SUNDRY NOTICES AND REPORTS ON WELLS

8. Well Name and No.
Poker Lake Unit 363H

BOPCO,L.P. is requesting approval to amend point 4 Pressure Control Equipment in the original APD as attached.

POINT 4: PRESSURE CONTROL EQUIPMENT (SEE ATTACHED DIAGRAM 2)

Latshaw 13-5/8" X 3-M BOPE (2 Rams and Rotating Head) & Closed Loop System Equipment Schematic Diagram 2

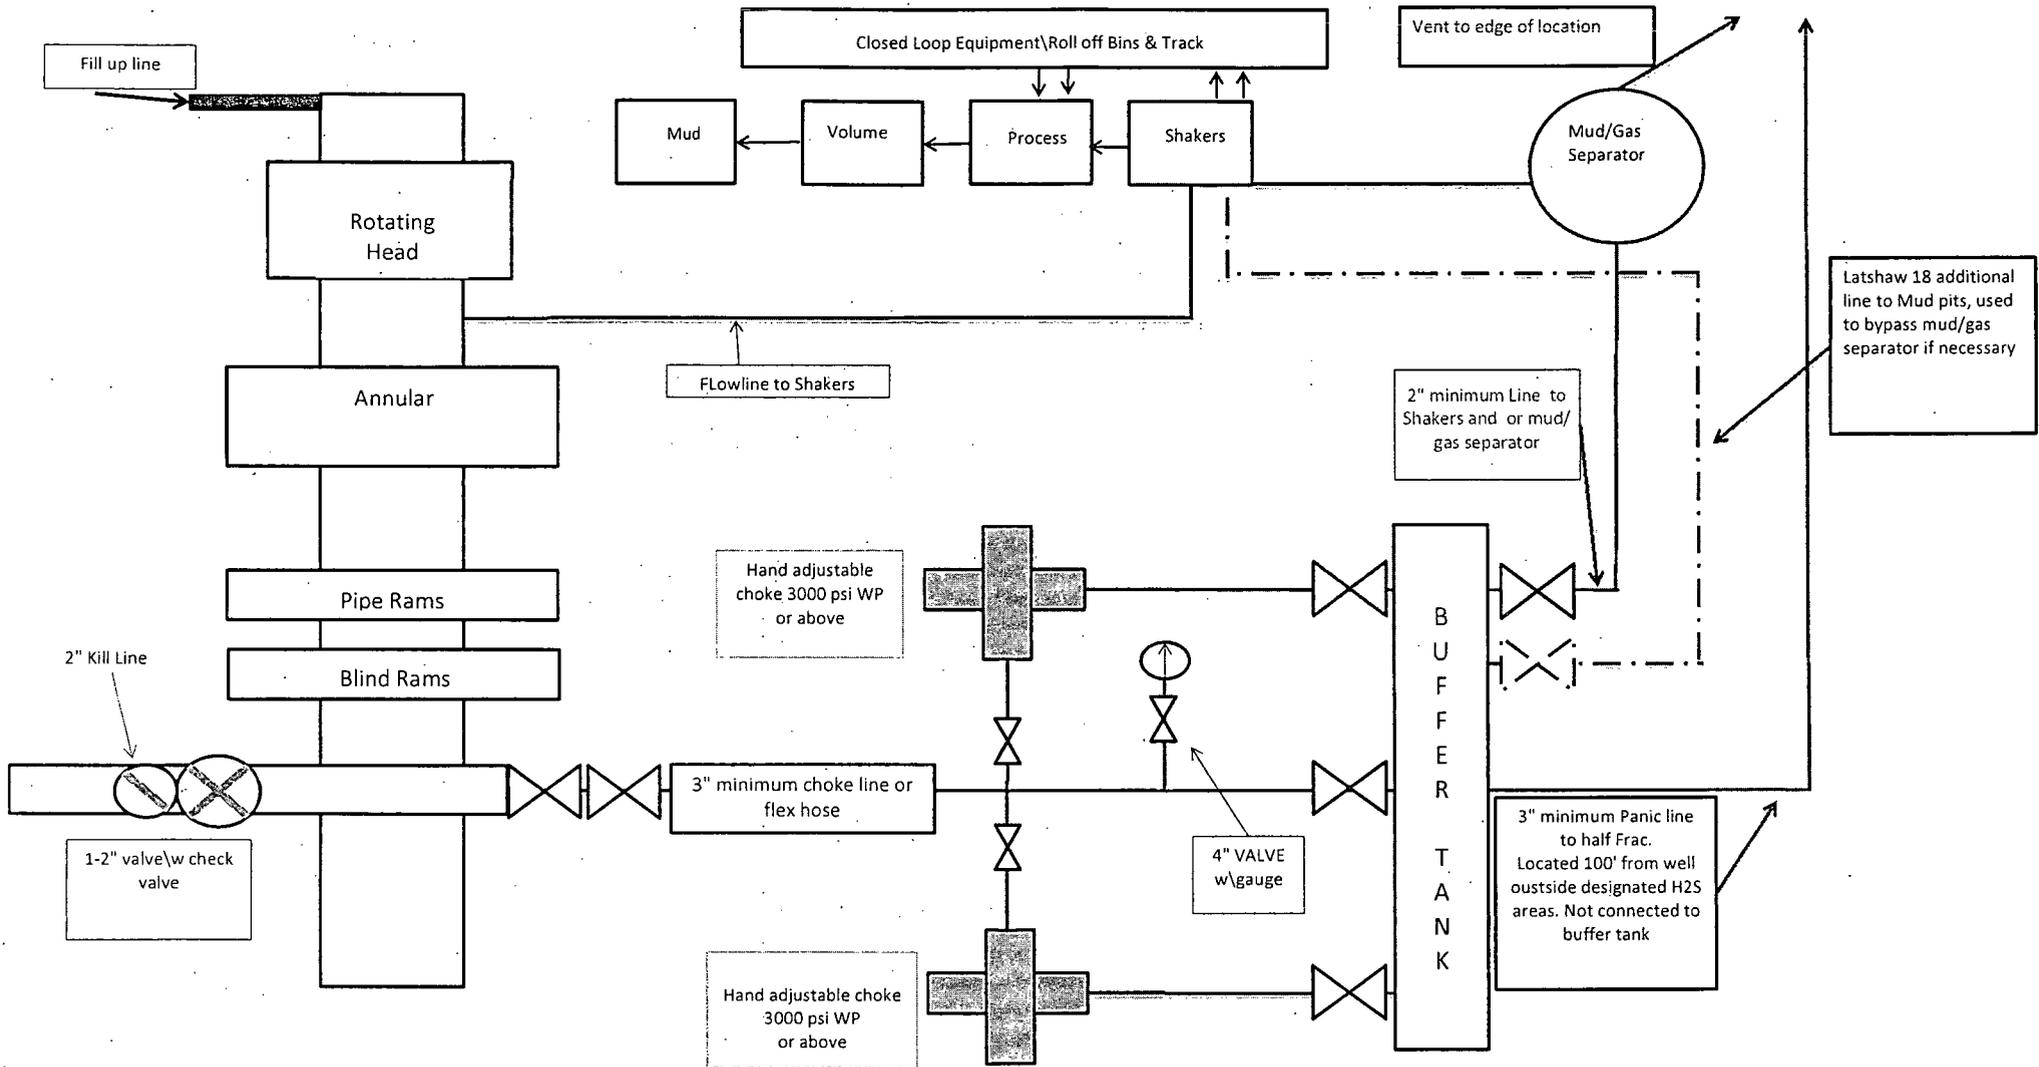
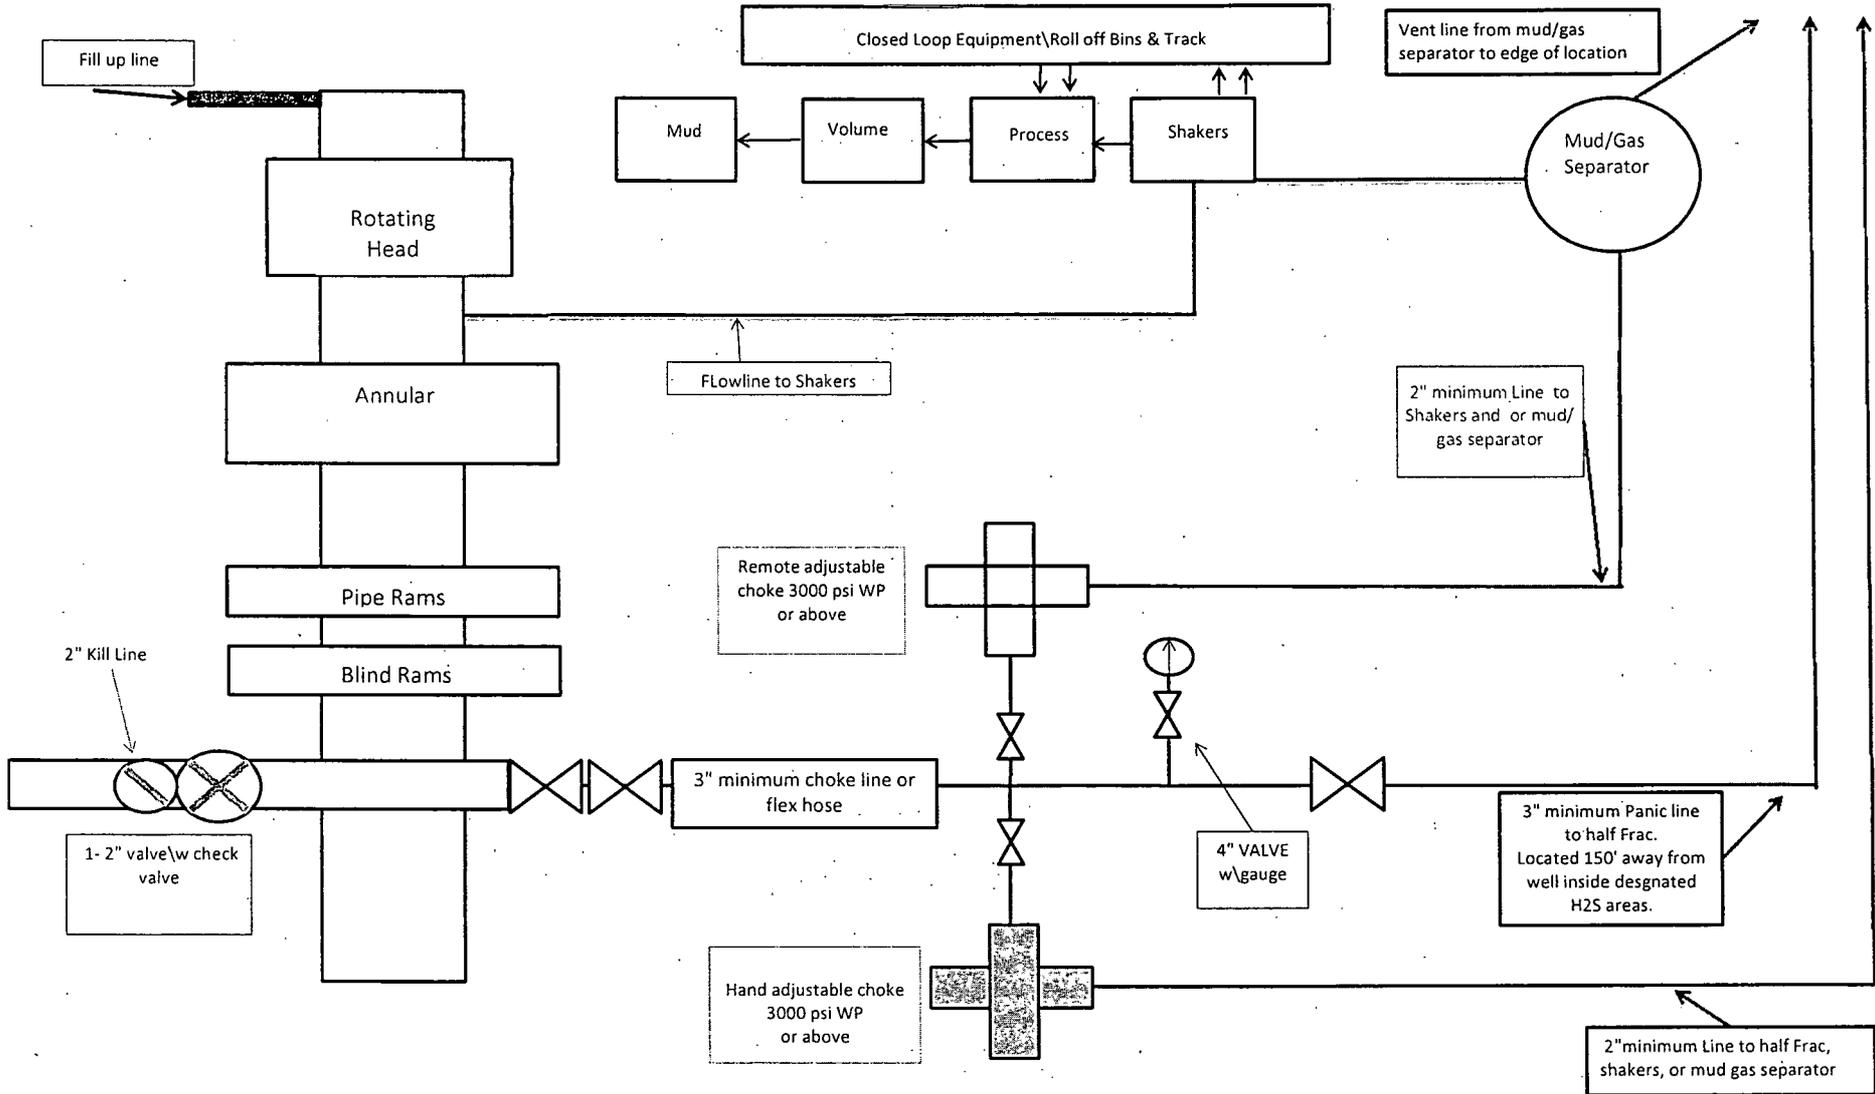
After running the 13-3/8" surface casing, a 13-5/8" BOP/BOPE system with a minimum rating of 3M will be installed, used, maintained and tested as per Onshore Order 2. In addition to the high pressure test, a low pressure (250-300 psig) test will be performed.

After running the 9-5/8" intermediate casing, a 13-5/8" or 11" BOP/BOPE system with a minimum rating of 3M will be installed on the 9-5/8" intermediate casing spool (8-3/4" open hole), used, maintained and tested as per Onshore Order 2. In addition to the high pressure test, a low pressure (250-300 psig) test will be performed.

After running the 7" intermediate casing, a 13-5/8" or 11" BOP/BOPE system with a minimum rating of 3M will be installed on the 9-5/8" intermediate casing spool (8-3/4" open hole), used, maintained and tested as per Onshore Order 2. In addition to the high pressure test, a low pressure (250-300 psig) test will be performed.
